The Garden House
Hampstead

Planning Condition Discharge Report - Storm Drainage

Project Number 1377
Author: E. Partridge
Checked: M. Jones

September 2019

Appendix 3 – Drainage Layout Drawing

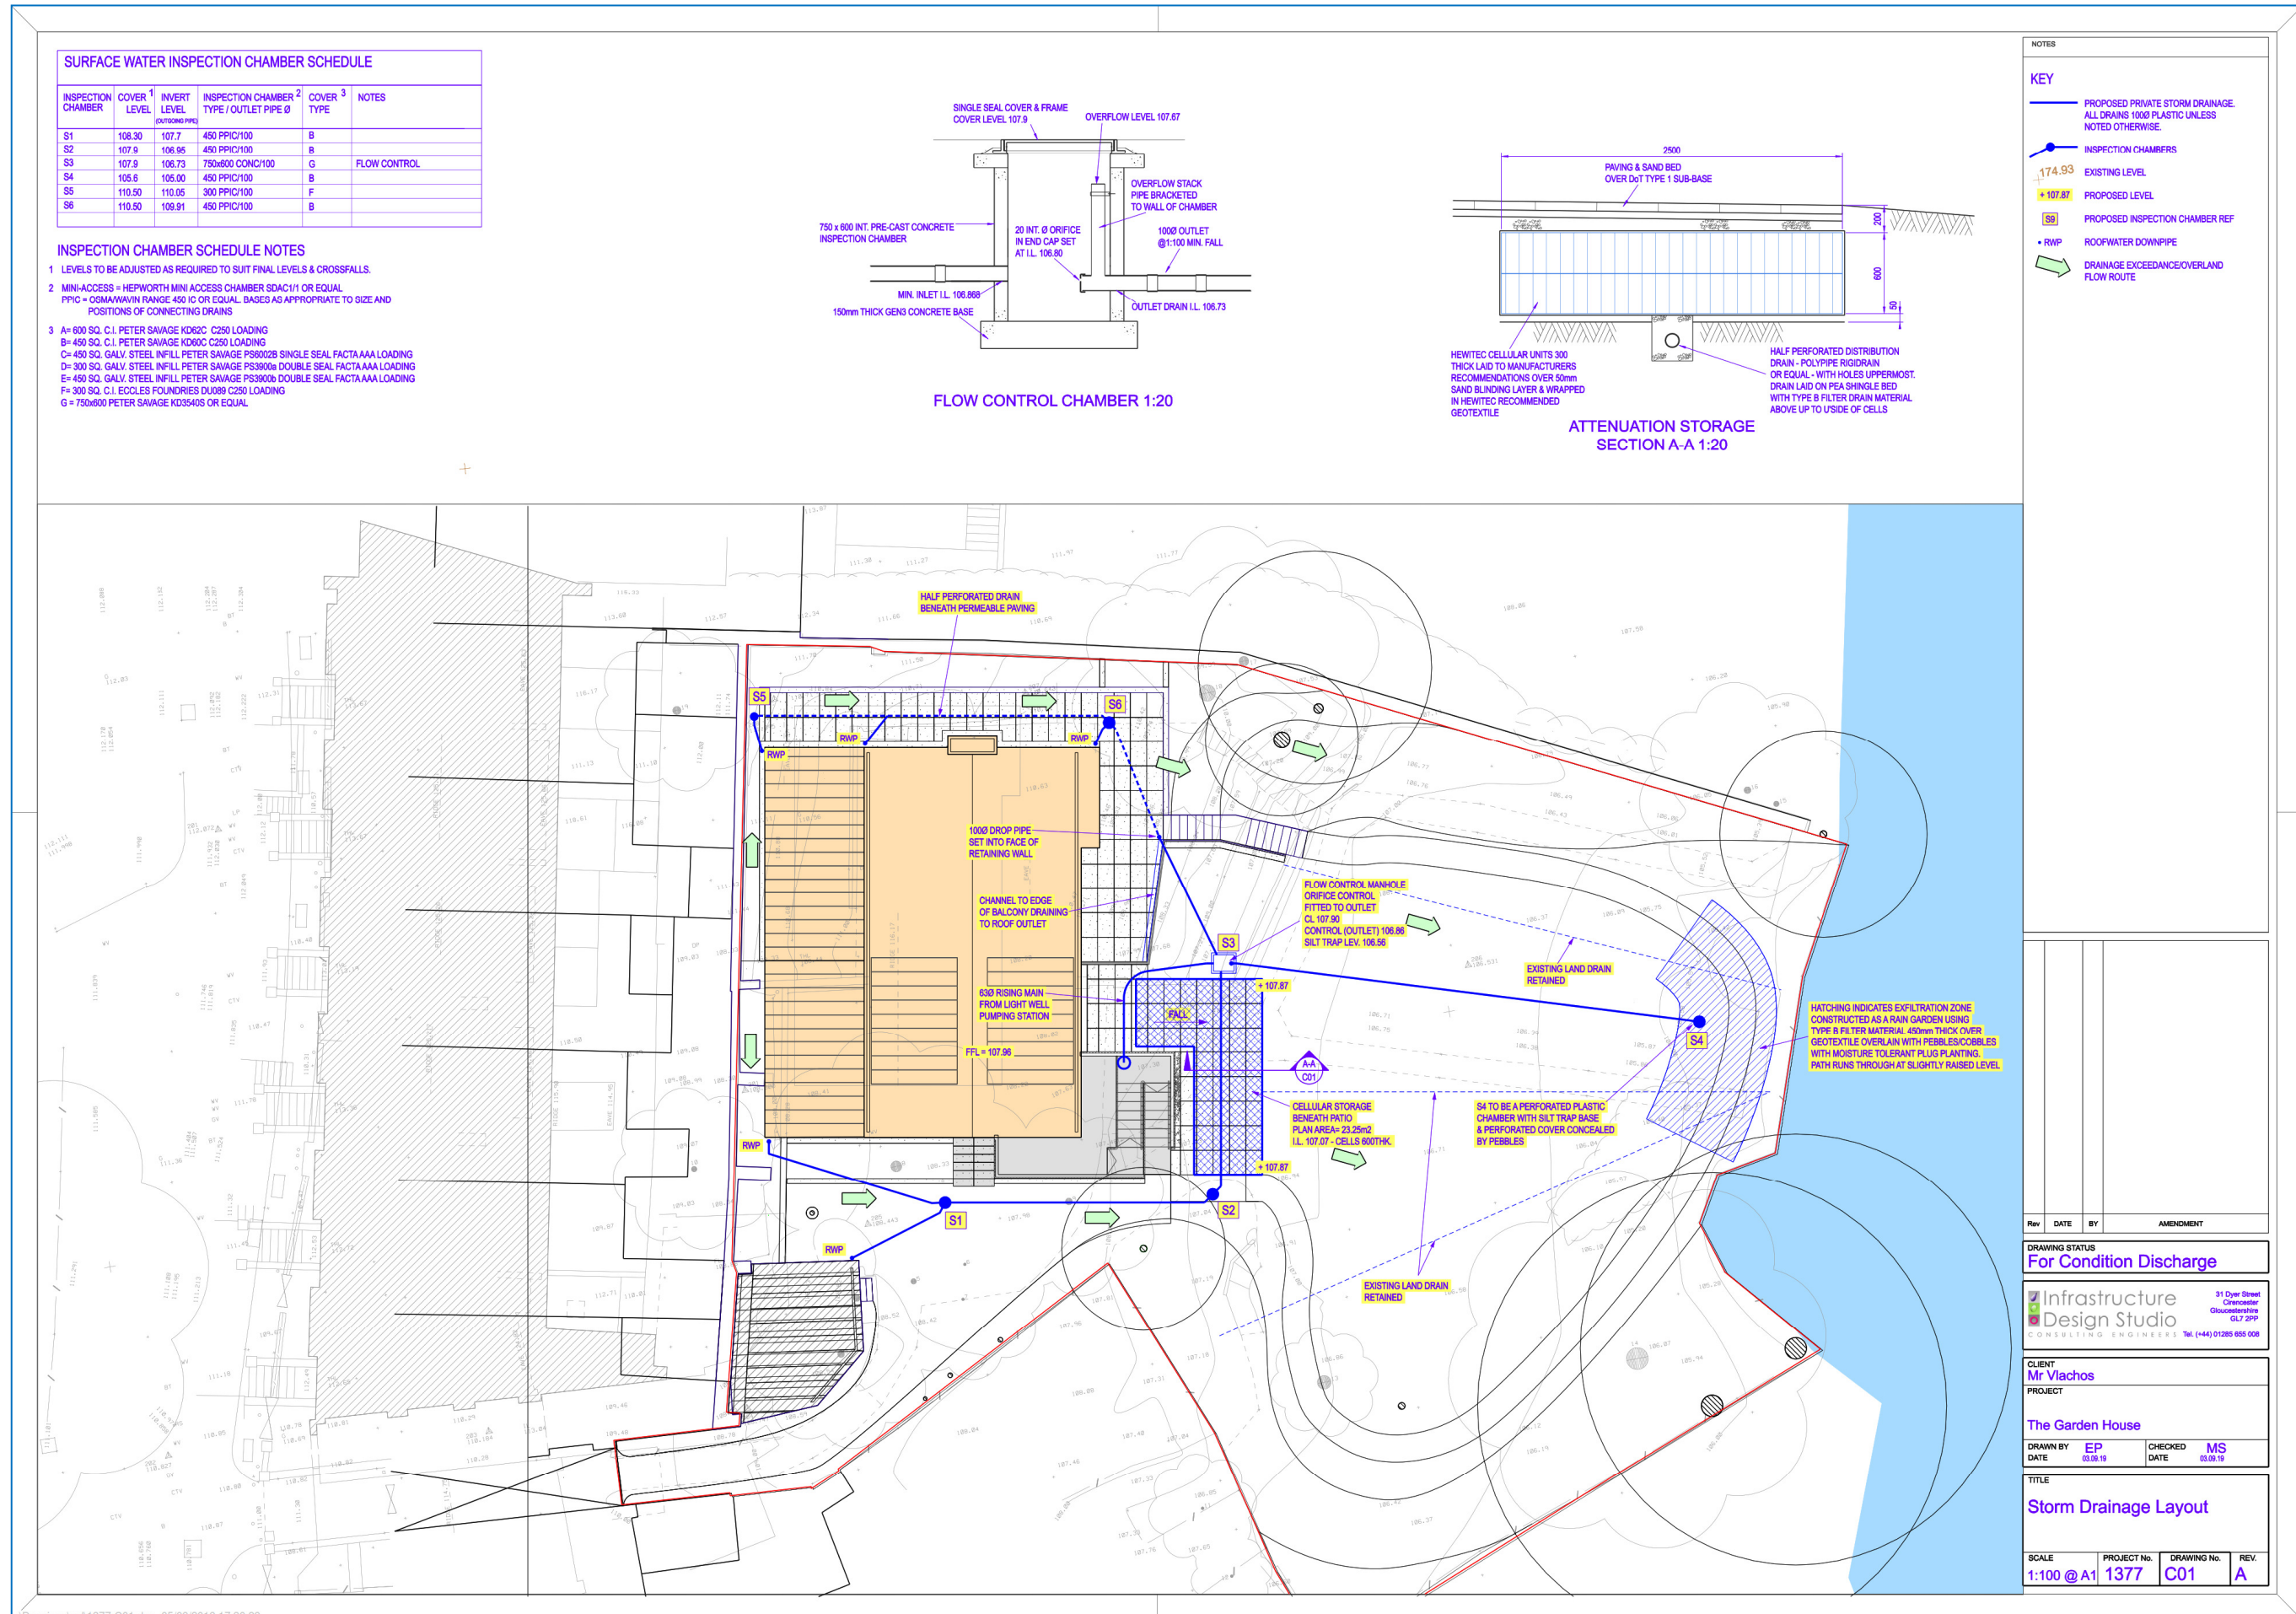
8. Provide evidence of consent/approval to discharge at the proposed rate and location into Vale of Heath Pond
9. Provide an updated drainage layout plan which details all elements of the proposed site drainage, including pipe size, gradients, invert levels and connections, location of the flow control device, proposed discharge rate and point(s) of discharge from the site

8. Provide an updated drainage layout plan which details all elements of the proposed site drainage, including pipe size, gradients, invert levels and connections, location of the flow control device, proposed discharge rate and point(s) of discharge from the site

Drawing 1377-C01 covers all the points requested. See Appendix 3. Discharge rates for a 100yr storm event are included in the calculations in Appendix 2. Pipe sizes have been checked against their contributing catchment areas and using 100dia drains at min 1:100 gradients the pipe capacities are more than adequate to carry the relevant flows.
